# **A12 Chelmsford to A120 widening scheme**

## **DEVELOPMENT CONSENT ORDER CHANGE APPLICATION CONSULTATION**

### **FLOOD RISK ASSESSMENT ADDENDUM**

**Development Consent Order Change Application:  
Flood Risk Assessment Addendum**

**Plate 1.1 New design proposals as part of the DCO change application in comparison with DCO design submitted in August 2022 (cluster area 1)\***

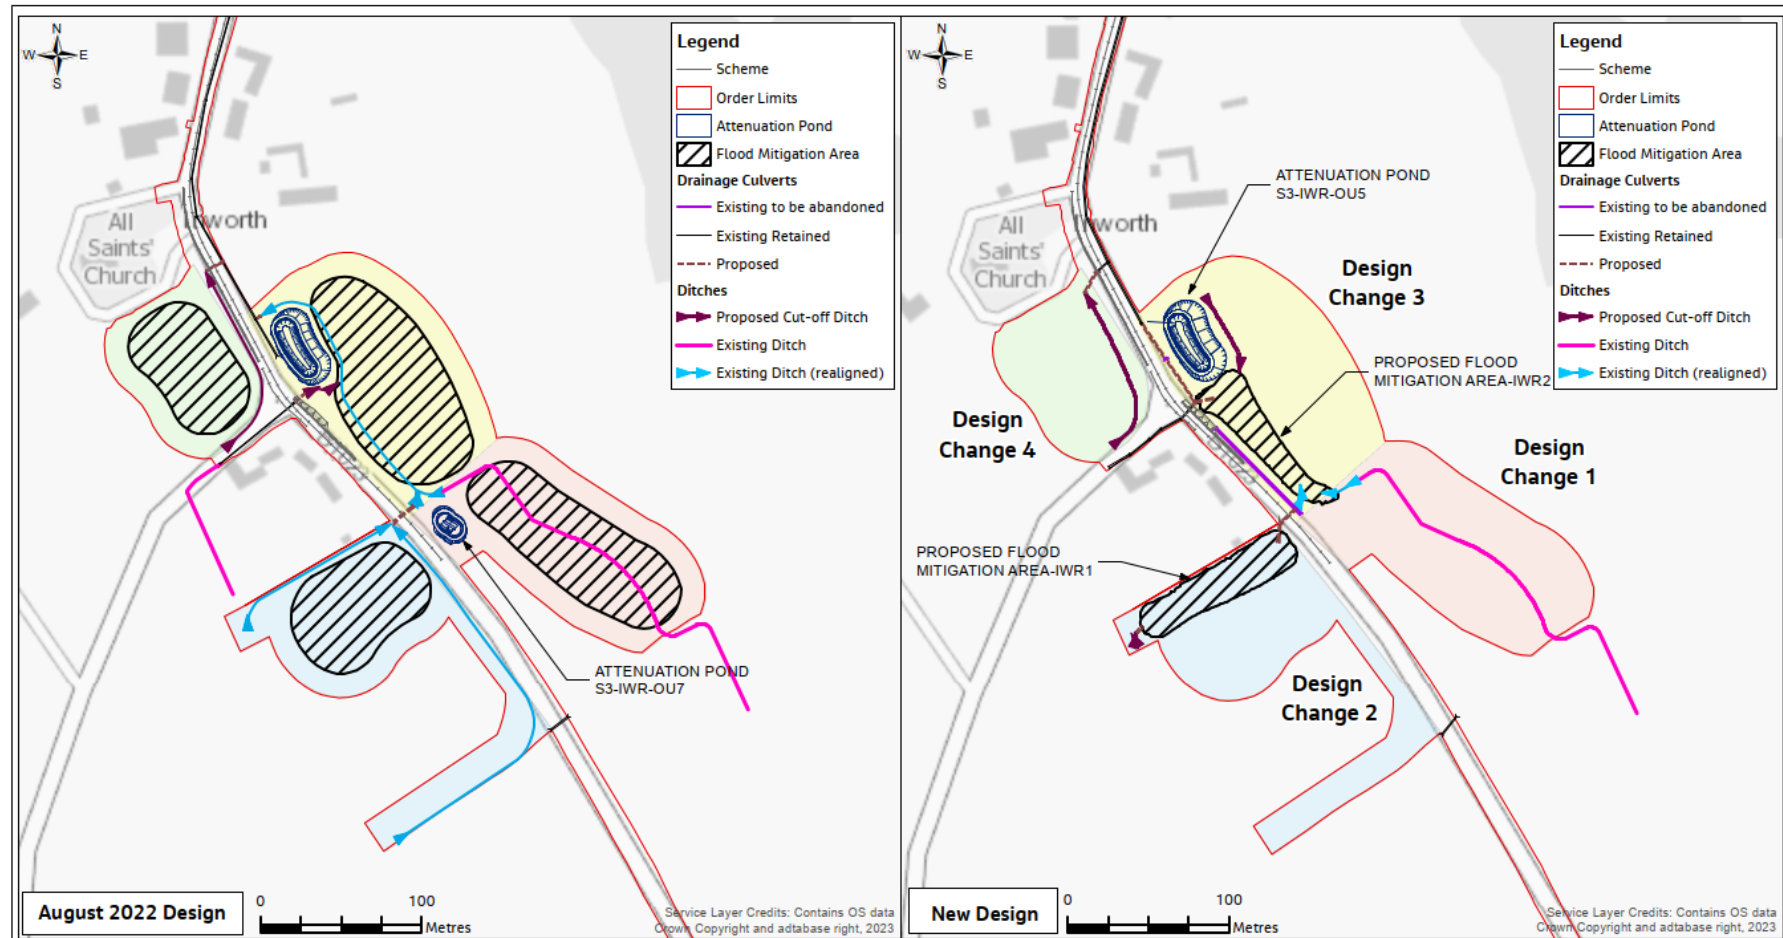
Land take area reference from Plate 1.1	New design solution
Design Change 1	<p><b>Attenuation pond S3-IWR-OU7 has been removed.</b> There are no highway widening works within the catchment S3-IWR-OU7 boundary. Hydraulic checks indicate minor increase in flows due to an increase in rainfall values for climate change allowance which will be manageable through localised upgrades to drainage collection features.</p> <p>The DCO design submitted in August 2022 included a flood mitigation storage area that would have required excavation over a gas main, the location of which was unknown at DCO stage design. The new design has taken this constraint into account and developed the solution through hydraulic modelling that confirmed <b>removal of the flood mitigation measures in this area.</b></p>
Design Change 2	<p><b>New drainage ditches adjacent to the B1023 near Inworth</b> that were considered previously as part of flood risk mitigation <b>are not required.</b></p> <p>New design proposal has considered the constraint imposed by an existing gas main and has been informed by hydraulic modelling. The <b>new design (proposed flood mitigation - IWR1) provides a reduction in the flood mitigation storage area requirements.</b></p>

Design Change 3	<p><b>Attenuation pond S3-IWR-OU5 has been retained.</b></p> <p>The <b>new design proposal (proposed flood mitigation – IWR2)</b> has been informed through hydraulic modelling and provides a <b>reduction in the flood mitigation storage area requirements.</b></p>
Design Change 4	<p>The new design has been developed through hydraulic modelling which has confirmed the <b>removal of flood mitigation measures in this area.</b></p> <p>The <b>proposed drainage ditch is retained,</b> although it is required to move further away from the road and is enlarged to capture the overland runoff from the catchment upstream which forms part of the overall solution for flood mitigation measures in this area.</p>

**Plate 1.2 New design proposals as part of the DCO change application in comparison with DCO design submitted in August 2022 (cluster area 2)\***

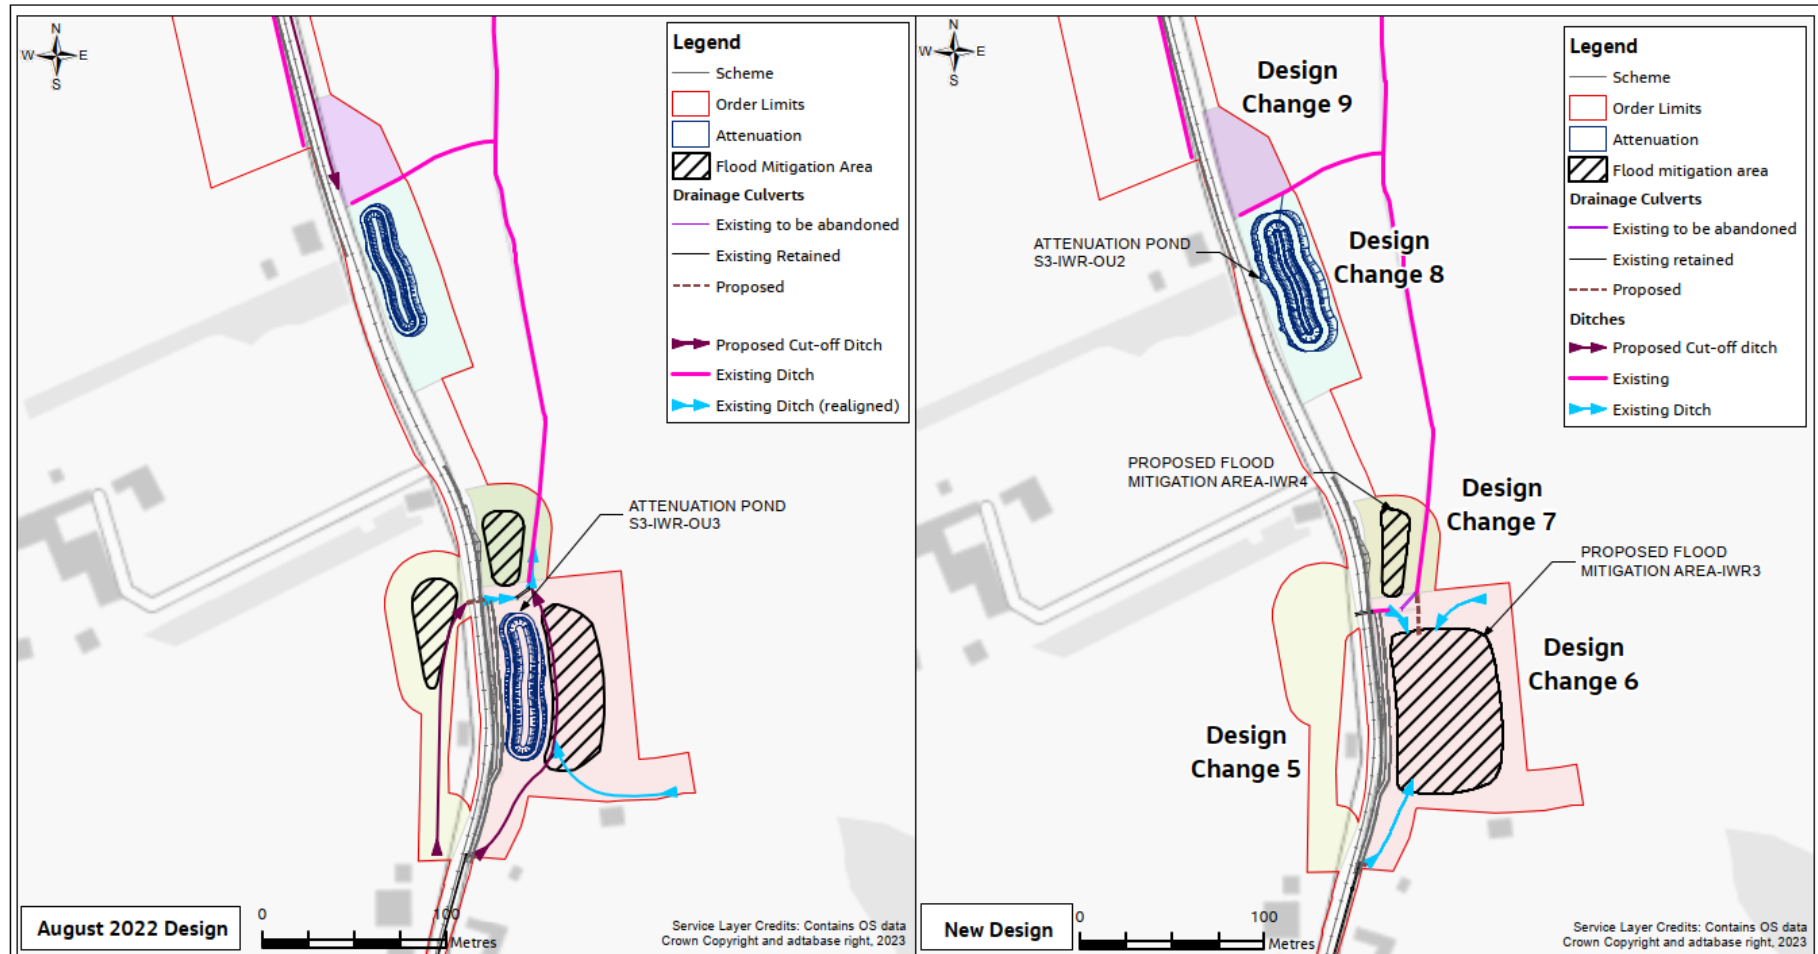
Land take area reference from Plate 1.2	New design solution
Design Change 5	<b>New drainage ditch and flood mitigation storage area</b> adjacent to the B1023, near Inworth, that were considered for the design submitted at DCO <b>are not required</b> . Existing field drains/ditches found in the location of the new drainage ditch will be retained.
Design Change 6	A new design solution has been developed to optimise the combined design solutions that would work for the mitigation required for the highway drainage (attenuation storage) and for the flood risk mitigation storage. <b>Attenuation pond S3-IWR-OU3 has been removed</b> and the highway drainage catchment is now diverted to attenuation pond S3-IWR-OU2.  <b>Flood mitigation storage area (proposed flood mitigation area – IWR3)</b> has been informed through hydraulic modelling and has <b>increased in area</b> (i.e. in comparison to the DCO design submitted in August 2022 but is still within the Order Limits).

Design Change 7	<b>Flood mitigation storage area (proposed flood mitigation area – IWR4)</b> is proposed to be retained. Minor adjustments will be required to minimise the impact to the existing foul sewer in the area.
Design Change 8	<b>Attenuation Pond S3-IWR-OU2 is retained</b> . Note there has been an <b>increase in the attenuation storage volume for attenuation pond S3-IWR-OU2</b> (i.e. in comparison to the DCO design submitted in August 2022 but is still within Order Limits) as a result of the additional highway drainage catchment draining to this attenuation storage pond which was previously associated to attenuation pond S3-IWR-OU3 (i.e. Design Change 6). Attenuation pond S3-IWR-OU2 has been adjusted locally to minimise the impact on the existing foul sewer located in this area.
Design Change 9	This area is considered as potential attenuation for the highway drainage for catchment S3-IWR-OU1 that will be <b>reduced in size</b> as this catchment now drains through proposed catchment S3-OU8B+OU8D. Refer to consultation Sheet 20 of the updated Surface Water Drainage plan in Map Book 4 [TR010060/EXAM/10.8] submitted with the DCO change application for the revised catchments for the proposed S3-OU8B + OU8D catchments that includes the diverted existing S3-IWR-OU1 catchment.
